Re: Proposed Rule Change on Technical Standards for Wind Generation

ATTACHMENT B - PROPOSED RULE CHANGES IN MARK-UP WITH EXPLANATION

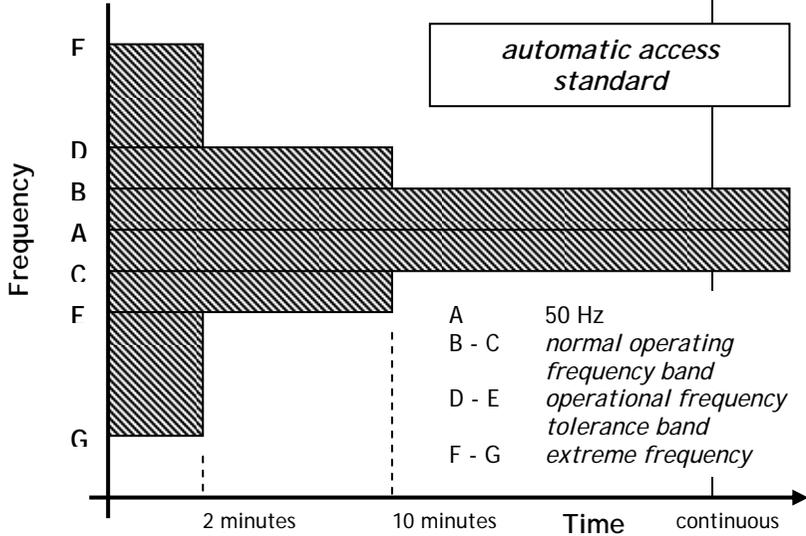
Affected clause	Clause with proposed amendments	Reason	NGF Comments
	<p><i>systems that would clear a fault at the location at which the new connection would be connected into the existing transmission system or distribution system;</i></p> <p>(3) the expected limits of <i>voltage</i> fluctuation, harmonic <i>voltage</i> distortion and <i>voltage</i> unbalance at the <i>connection point</i> with the <i>generating unit</i> not <i>synchronised</i>;</p> <p>(4) technical information relevant to the <i>connection point</i> with the <i>generating unit</i> not <i>synchronised</i> including equivalent source impedance information, sufficient to estimate fault levels, voltage fluctuations, harmonic voltage distortion (<u>for harmonics relevant to the generating system</u>) and voltage unbalance; and</p> <p>(5) any other information or data not being confidential information relating to the performance of the <i>Network Service Provider's facilities—national grid</i> that is reasonably necessary for the <i>Connection Applicant</i> to prepare an <i>application to connect, including, without limitation</i>:</p> <p>(i) a model of the power system, including relevant considered projects and the range of expected operating conditions, sufficient to carry out load flow and dynamic simulations; and</p> <p>(ii) information on inter-regional and intra-regional power transfer capabilities and relevant plant ratings.</p> <p>except where the Connection Applicant agrees the Network Service Provider may provide alternative or less detailed technical information in satisfaction of this clause S5.2.4(e).</p> <p>(d) All information provided under this clause S5.2.4 must be treated as <i>confidential information</i>.</p>	<p>Clause S5.2.4(d) reiterates the requirement from clause 5.3.8 that recipients must treat information provided as confidential.</p>

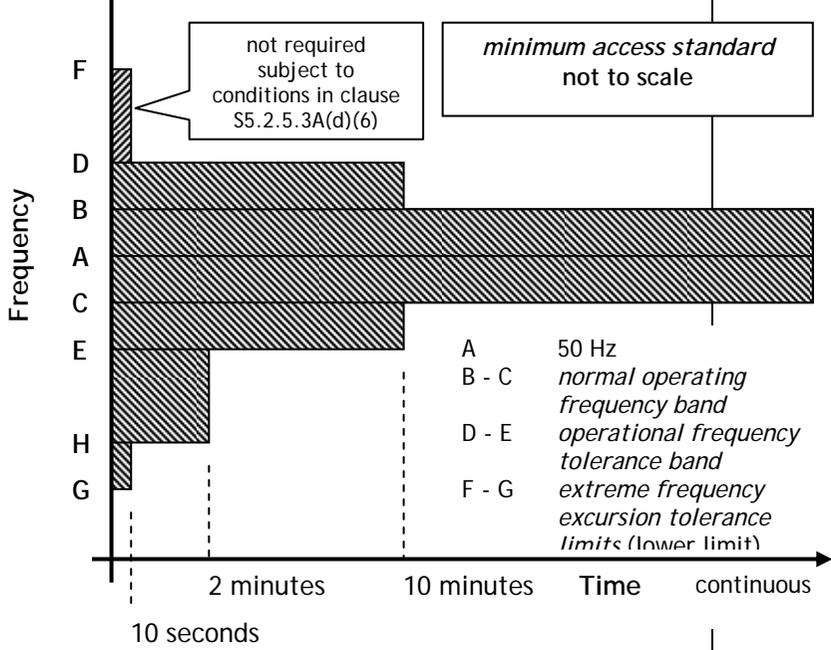
Affected clause	Clause with proposed amendments	Reason	NGF Comments
	<p><u>normal and planned <i>outage</i> operating conditions of the <i>power system</i>, taking into account at least existing and <i>considered projects</i>;</u></p> <p>(2) <u>may negotiate either a range of <i>reactive power</i> absorption and supply, or a range of <i>power factor</i>, at the <i>connection point</i>, within which the <i>plant</i> must be operated; and;</u></p> <p>(3) <u>may negotiate a limit that describes how the <i>reactive power capability</i> varies as a function of active power output <i>active power output</i> due to a design characteristic of the <i>plant</i>.</u></p> <p>(d) The <i>Generator</i> may reach a commercial arrangement with the <i>Network Service Provider</i> or a <i>Registered Participant</i> for the provision of <i>reactive power capability</i> sufficient to ensure the <i>Generator's</i> obligation under this clause is met. If the proposed <i>generating system</i> is not capable of the level of performance established under clause S5.2.5.1(c)(1), the <i>Network Service Provider</i> may:</p> <p>(1) <u>require the <i>Generator</i> to pay compensation to the <i>Network Service Provider</i> for the provision of the deficit of <i>reactive power</i> (supply and absorption) from within the <i>network</i>;</u></p> <p>(2) <u>allow the <i>Generator</i> to install additional equipment <i>connecting</i> at the <i>generating system's connection point</i> or another location, to provide the deficit of <i>reactive power</i> (supply and absorption), which equipment is deemed to be part of the <i>generating system</i>;</u></p> <p>(3) <u>allow the <i>Generator</i> to reach a commercial arrangement with a <i>Registered Participant</i> to provide the deficit of <i>reactive power</i> (supply and absorption); or</u></p> <p>(4) <u>if the inability to meet the performance level only occurs for particular operating conditions, agree to and document as part of the <i>access standard</i>,</u></p>	<p>Sub-clauses (2) and (3) specify greater details about what can be negotiated and this will mean that alternative methods of providing reactive power capability more economically will be explicitly available.</p> <p>The automatic access standard has been extended to apply to any technology, and not just to synchronous plant, and to apply to generating systems.</p> <p>The basis of negotiation has been amended to clarify it, and provide flexibility in the way that reactive power is specified.</p>	<p>Should also be able to negotiate the point at which the requirement is met (connection point or machine terminals)</p>
